P02	19/05/23	Response to RFI
P01	25/04/22	Issued For Planning
Revision Number	Date	Drawn / Details of Issue / Revision
Issues & Revisions

Project Details:
**Dalguise
 Monkstown**

Drawing Title:
Proposed Elevations + Sections - Block B

MKS-RAU-B-ZZ-DR-AR-200

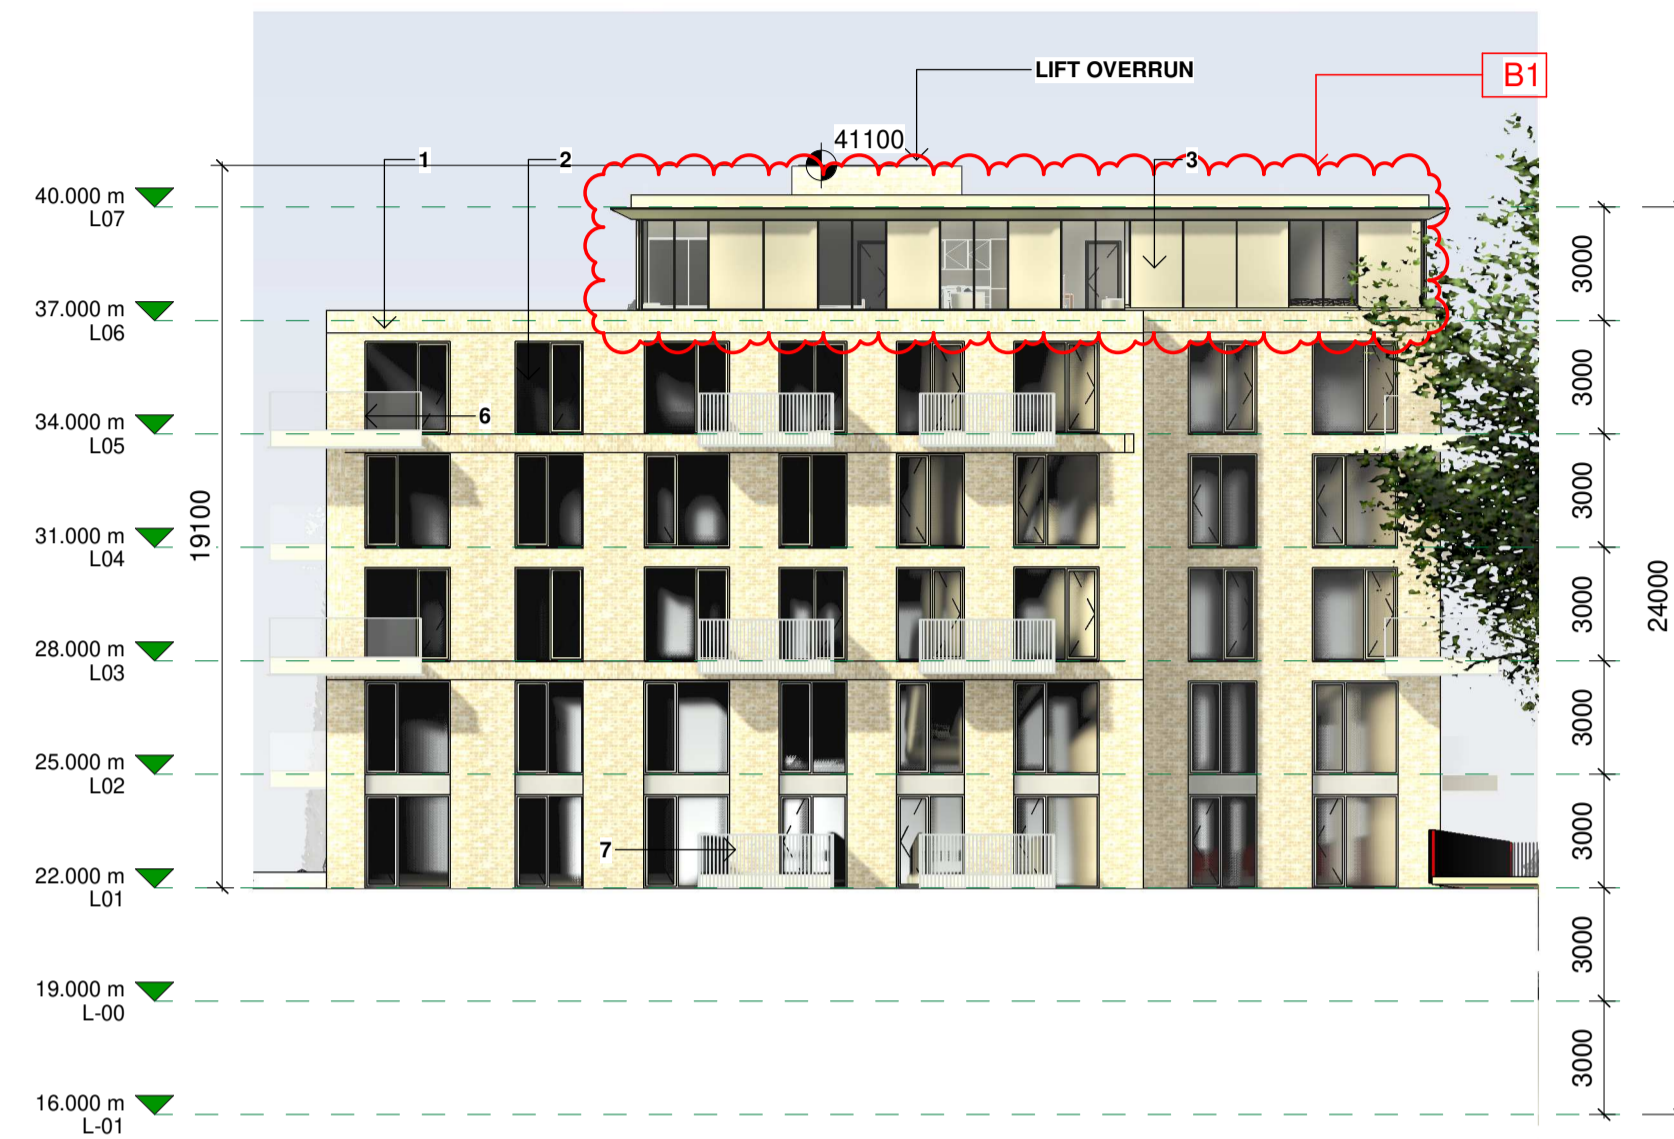
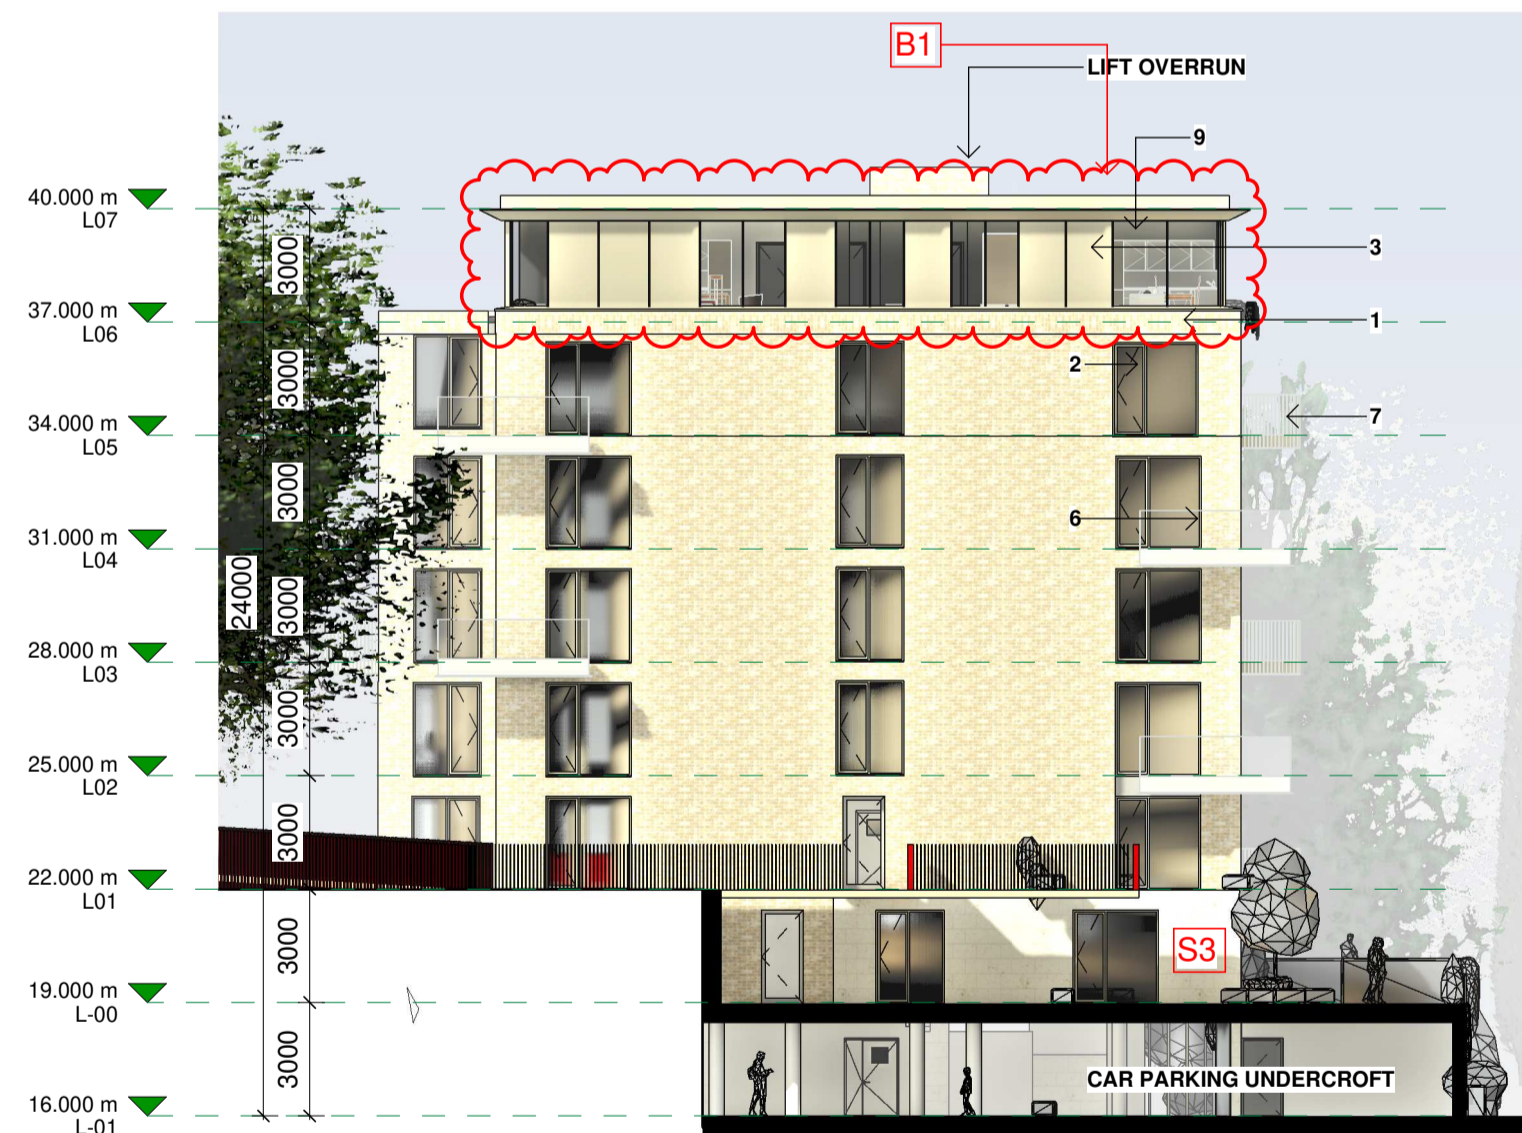
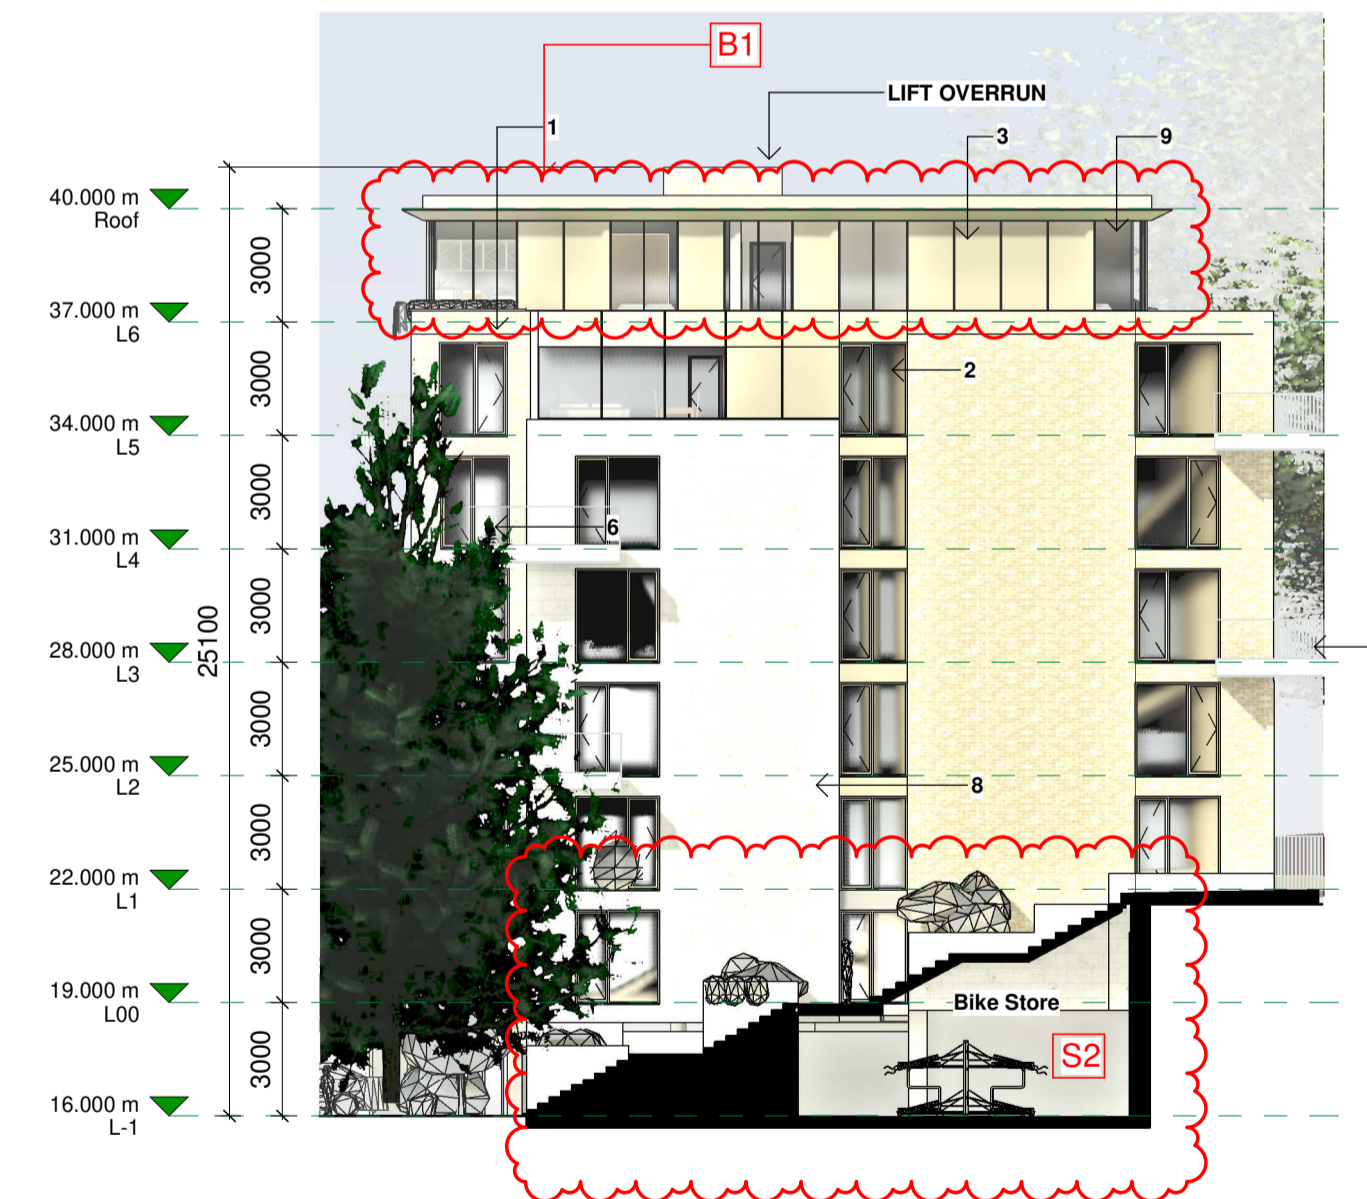
- B1. Tonal Change at Penthouse level.**
- S2. Re-alignment of the Basement Car Park Entrance. The Entrance is now located underneath Block B.**
- S3. New external Amenity space added ground floor between Block B+C (Refer to HQA for area)**
- B4. New private balcony added to B_00_01 (Refer to HQA for area)**
